APPLICATION FOR SOIL INVESTIGATION

SITE EVALUATION

S.I.R. NO. 20491

SIR. NO. 20491
T.C. NO. PO 019-191-14
DATE: 2-14-84

**See Diagram on Back (includes: soil areas, property lines, roads, streams, gullies, wet areas, fill areas, wells, water bodies, slopes)

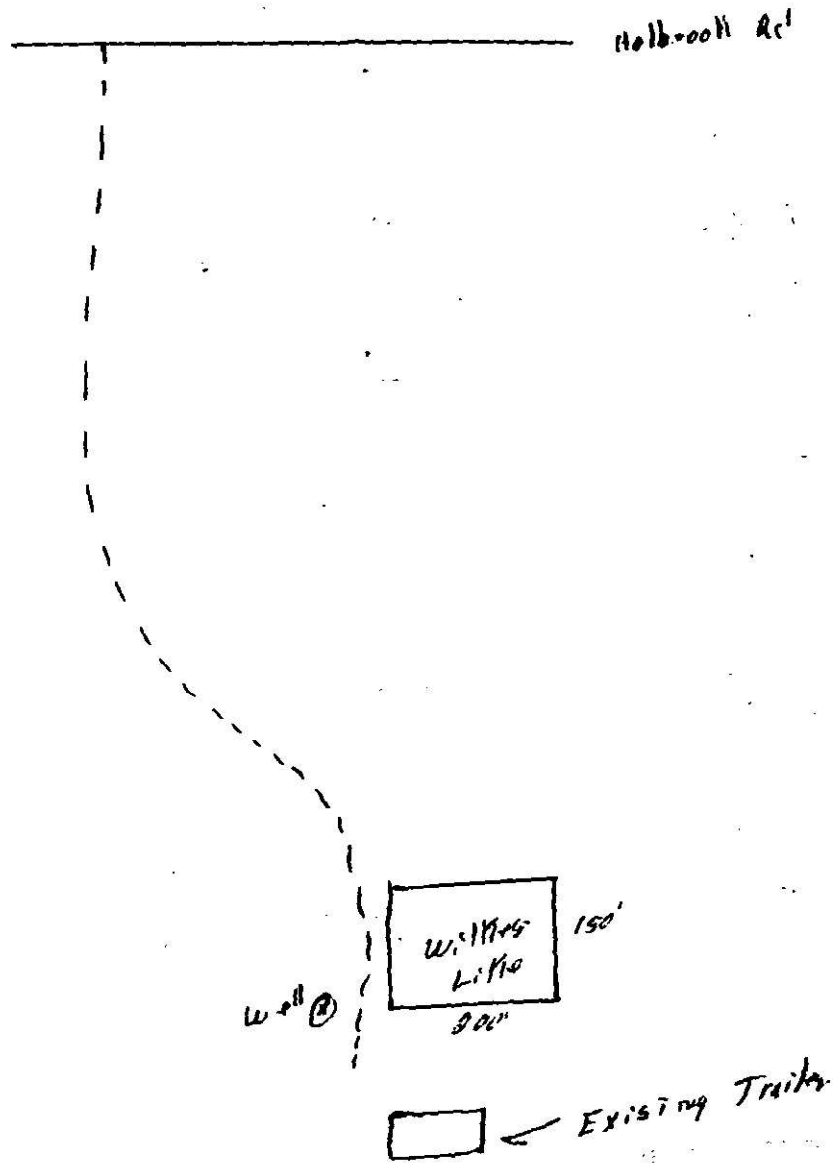
FACTORS	AREA 1	AREA 2	AREA 3	AREA 4
1. SLOPE (%)	S (PS) U 2 8%	S PS U	S PS U	S PS U
2. SOIL TEXTURE (12-36 inches) Sandy, Loamy, Clayey (Note 2-1 Clay)	S PS (U) 2-1 Clay	S PS U	S PS U	S PS U
3. SOIL STRUCTURE (12-36 inches)	S (PS) U Weak Blocky	S PS U	S PS U	S PS U
4. SOIL DEPTH (inches)	S PS (U) 6-20"	S PS U	S PS U	S PS U
5. RESTRICTIVE HORIZONS (Inches) (Impervious strata, Rock)	S PS (U) 6 30" To saprolite	S PS U	S PS U	S PS U
6. SOIL DRAINAGE/GROUNDWATER (external and internal)	S (PS) U 7 36" To ground water	S PS U	S PS U	S PS U
7. OTHER (Specify)	S PS U	S PS U	S PS U	S PS U
8. SOIL GROUP	IVB			
9. SITE CLASSIFICATION	unsuitable			
10. SOIL SERIES	Wilkes-Like

Holbrook Rd
Well
150'
90'
Existing Trailer

At your request, a field investigation was conducted on the property designated above and was classified unsuitable for the installation of a ground absorption sewage disposal system. A copy of the site evaluation report is enclosed for your information.
